Service Bulletin

REF: JD 05/93

12 INTRODUCTION OF GRADED CRANKSHAFT BEARINGS

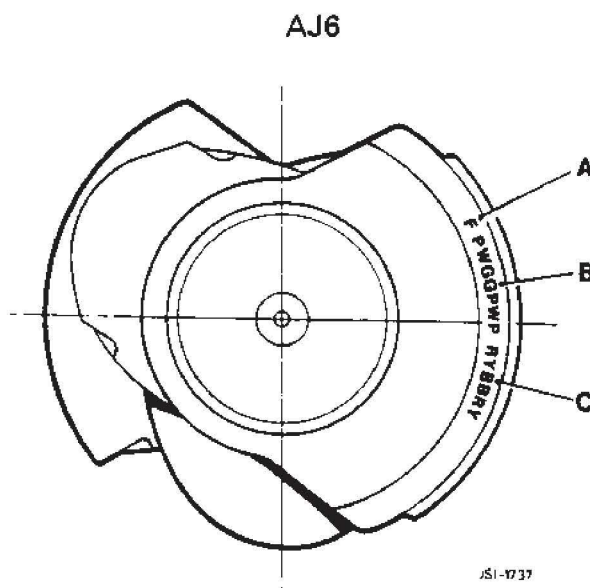
The three different grade diameters of the journals and pins are represented by a letter which corresponds to a colour, i.e. "P" equals Pink, "R" equals Red, etc. The grade of each individual journal and pin on each crankshaft is identified by having the grading diameter colour stamped on the No 1 balance weight, indicating the grade of shell to be fitted, as follows:

The bearing shell is identified by having the colour on one of its edges.

J51-1860

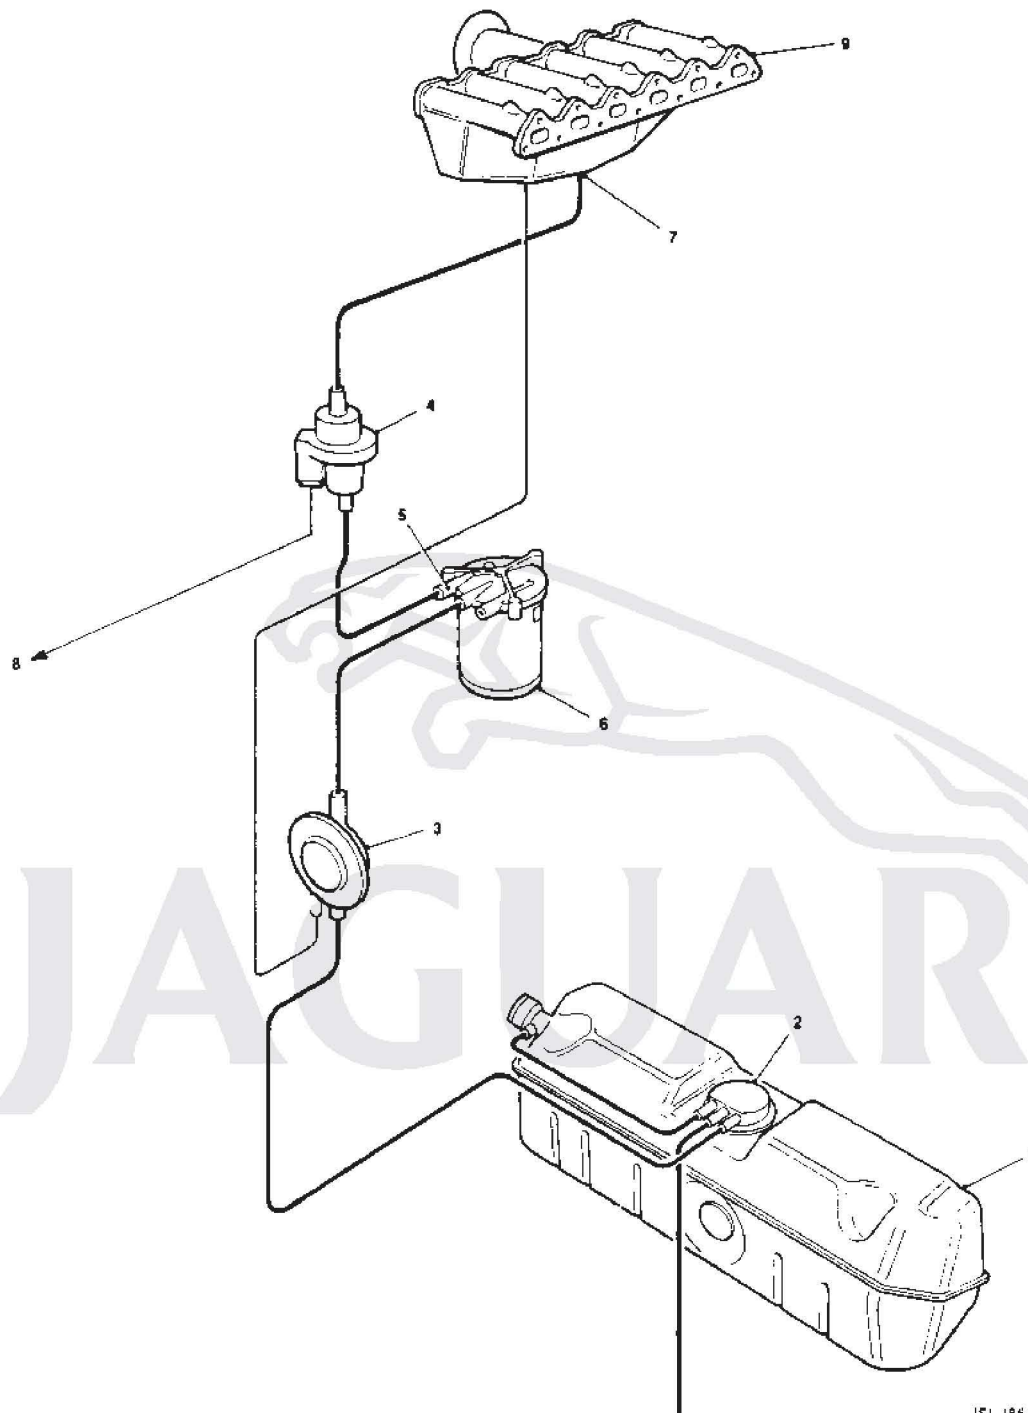
In order to meet stricter world-wide emission regulations, an Evaporative Emission Control System is now fitted to all Jaguar vehicles.

When a vehicle is at rest with the engine turned off, the flow of vapour is controlled by a pressure/vacuum relief valve (3, Fig 1), so that a low positive pressure is maintained in the fuel tank. If this pressure exceeds approximately 1.5 psi, the pressure/vacuum relief valve opens, to allow the excess pressure and fuel vapour to bleed into the charcoal canister, thus maintaining the low positive pressure.

The charcoal canister is connected to the vehicle's induction manifold via a purge control valve (Fig 1, item 4), the operation of which is controlled by an electrical signal from the engine management ECU, according to a pre-determined map.

Fig. 1.

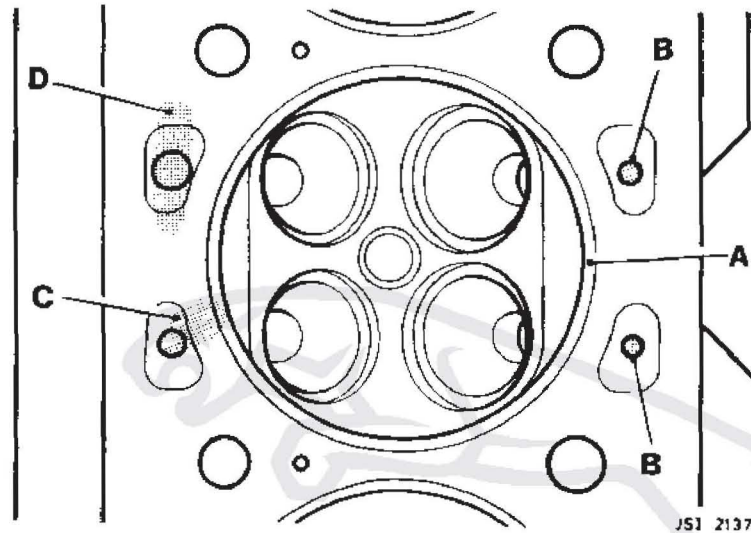
Provided that the eroded area (condition C, Fig.1.) does NOT extend into the area occupied by any firing ring, (Item 'A', Fig 1.), of the head gasket, using a head gasket as a template; a repair can be effected and there is no need to replace the cylinder head.

Where erosion has resulted in the formation of cavities in less critical areas around the coolant passages, (condition D, Fig. 1.), repair of the cylinder head should be undertaken. Careful filling of the cavities to restore the cylinder head face to its original surface profile may be undertaken by means of a proprietary 'Plastic Metal' (eg 'BELZONA'). A suitable product will be available shortly from Jaguar Parts Operations under Part No. JLM 11719.

On engines prior to VIN 677386 (XJ6) and VIN 187554 (XJS) the foundry practices involved in the manufacture of the cylinder head and the cylinder block resulted in elongated cored coolant passages at the upper face of the cylinder block, facing small diameter drilled passages in the cylinder head, separated by the gasket. Coolant flow between cylinder block and cylinder head is controlled by the diameter of the holes in the cylinder head gasket (Item B, Fig. 1.)

From the above VINs, the coolant apertures in the cylinder head have been enlarged to correspond with the apertures in the cylinder block; hence coolant can no longer be trapped between the cylinder head gasket and cylinder head face.

Fig. 1.

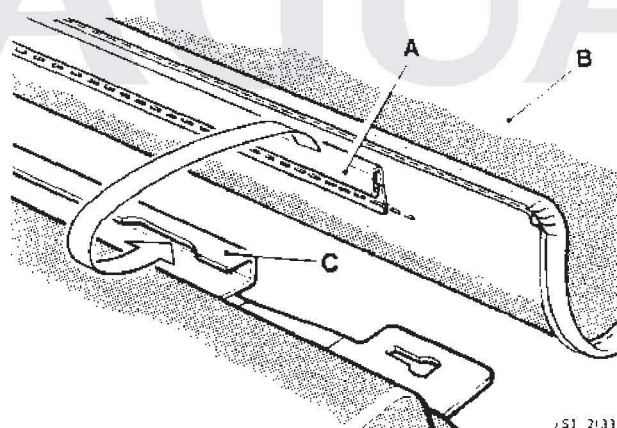
Introduced as a first improvement for 1994 Model Year vehicles, the rear edge of both the Driver's and Passenger's footwell carpet (Item 'B', Fig.1.) has a 'J' section plastic strip (Item 'A', Fig.1.), which engages with a corresponding section (Item 'C', Fig.1.) fixed to a bracket on the front of the Seat ECU cover.

1. Remove the Driver's side carpet from the footwell.
2. Remove the plastic protective covering.
3. Fold the carpet in half, and centralise it in the footwell.
4. Lift the rear edge of the carpet; align and fully engage the plastic 'J' section strip on the carpet to the metal bracket on the front of the seat ECU cover. (See Fig. 1.)
5. Align the carpet to the footwell; smooth the carpet flat into the footwell, particularly at the rear and sides of the carpet.
6. Fit the forward edge of the carpet under the control pedals, ensuring that the cut-out in the carpet is correctly aligned over the kick-down switch to provide the required clearance.

Fig. 2.

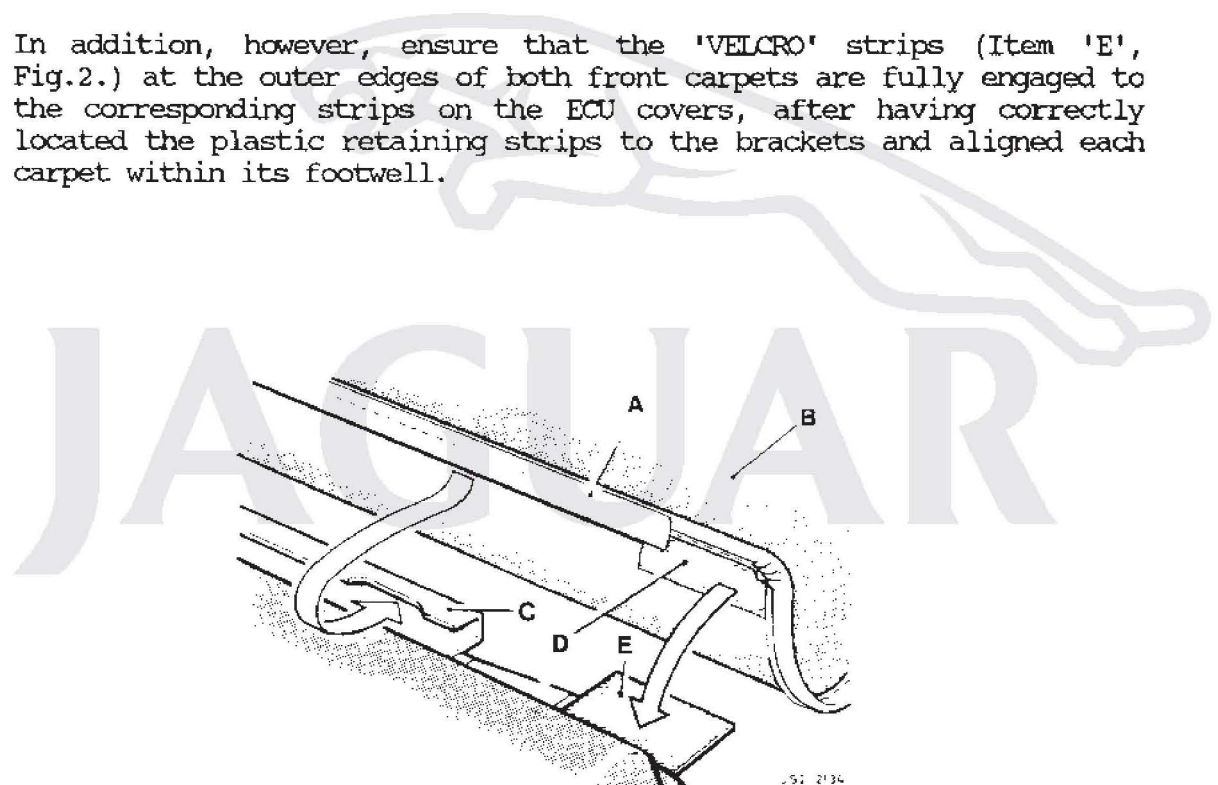
From the above VIN, the rear edges of both Driver's and Passenger's side carpets are similarly retained by flat plastic strips (Item 'A', Fig.2) engaging in brackets on the front of the seat ECU covers, (Item 'C', Fig.2.). In addition, a strip of 'VELCRO' fastening (Item 'D', Fig.2.) is fitted to the outer ends of both carpets, with a corresponding strip fitted to both ECU covers (Item 'E', Fig.2.), thus providing additional security to the footwell carpet location.

In addition, however, ensure that the 'VELCRO' strips (Item 'E', Fig.2.) at the outer edges of both front carpets are fully engaged to the corresponding strips on the ECU covers, after having correctly located the plastic retaining strips to the brackets and aligned each carpet within its footwell.

Fig. 1.

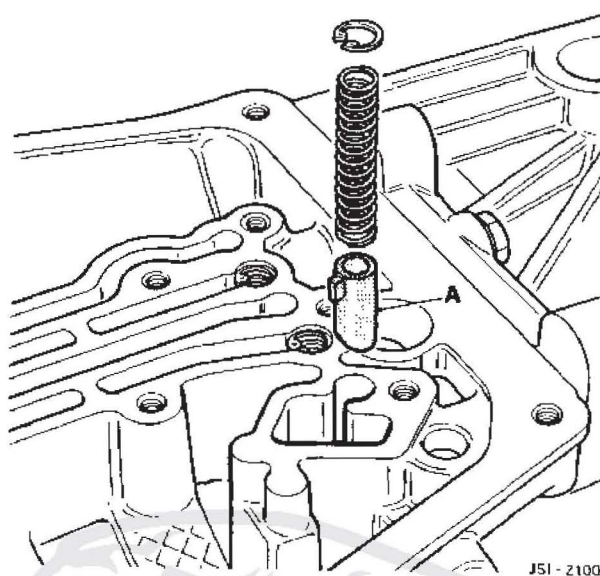
Remove the oil seal (Part No. JLM 863), Item A, Fig. 1.

Should this seal be incorrectly fitted or restricted, it may interfere with the transmission fluid pressure so as to cause a partial engagement of the torque converter lock-up clutch; in turn, this may cause the engine to stall at low/idling RPM.

Fit a new seal.

Fig. 2.

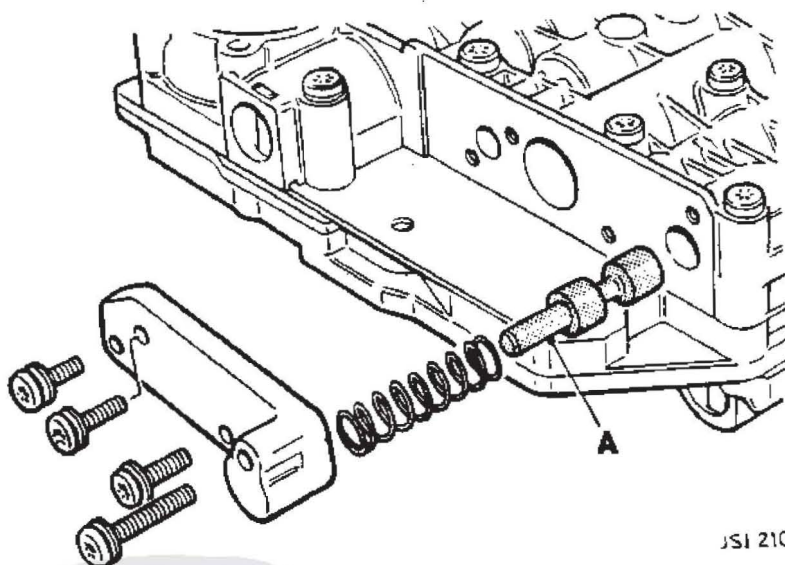
Remove the screws and retaining plate, allowing removal of the torque converter control valve, Item A, Fig. 2.

This valve controls the flow of fluid to the torque converter lock-up clutch. Should the valve stick, the resultant incorrect fluid flow may lead to the engine stalling at low RPM.

Clean the valve and its bore; check that the valve moves freely and smoothly in the bore.

Should there be any tendency of the valve to stick, gently lap the valve until a smooth-running fit is achieved.

Fig. 1. XJ12 MODELS

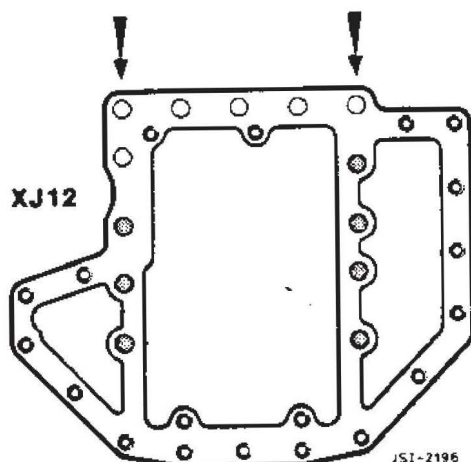
In addition to the possibility of oil leakage at either of the above gaskets, oil may also spread upwards along the threads of certain bolts which retain the sandwich plate and baffle tray. The heads of the bolts are in contact with oil, while the tops of the threads in the crankcase are exposed externally. In the event of the oil sump being removed to allow replacement of either gasket, the threads of the bolts concerned should be sealed by the application of 'Loctite 542' sealer.

The bolts concerned are identified by shading in Fig. 1 below and in Fig. 2 opposite.

Remove the bolts identified by shading; thoroughly clean and degrease them, using a suitable solvent; wipe or blow them dry.

When refitting the sandwich plate retaining bolts concerned, apply 'Loctite 542' to the bolt threads.

JSI-2207

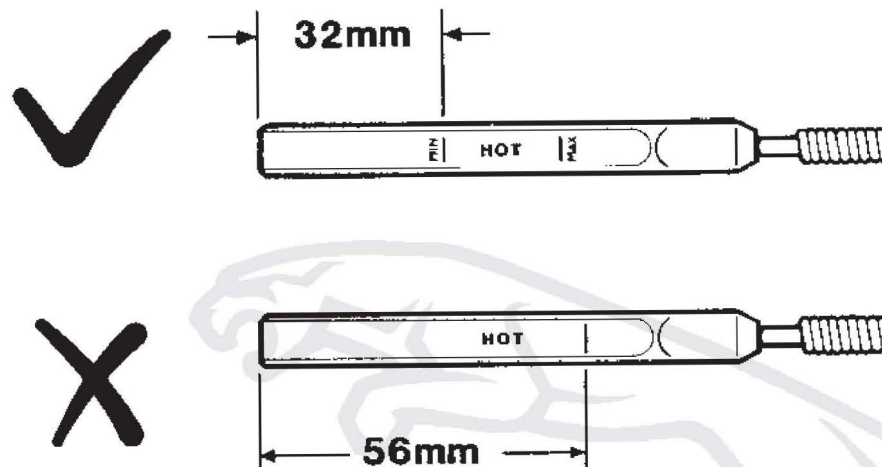
A small number of vehicles within the above VIN range may have been fitted with a dipstick of incorrect specification.

The dipstick may be identified by measurement between the the tip and the 'Min Hot' marking, as illustrated below:

CORRECT DIPSTICK: Measurement = 32 mm.

INCORRECT DIPSTICK: Measurement = 56 mm.

Where an incorrect dipstick is identified, it should be replaced by one of the correct specification, Part No. EBC 8409, the incorrect item being returned through normal Warranty channels.
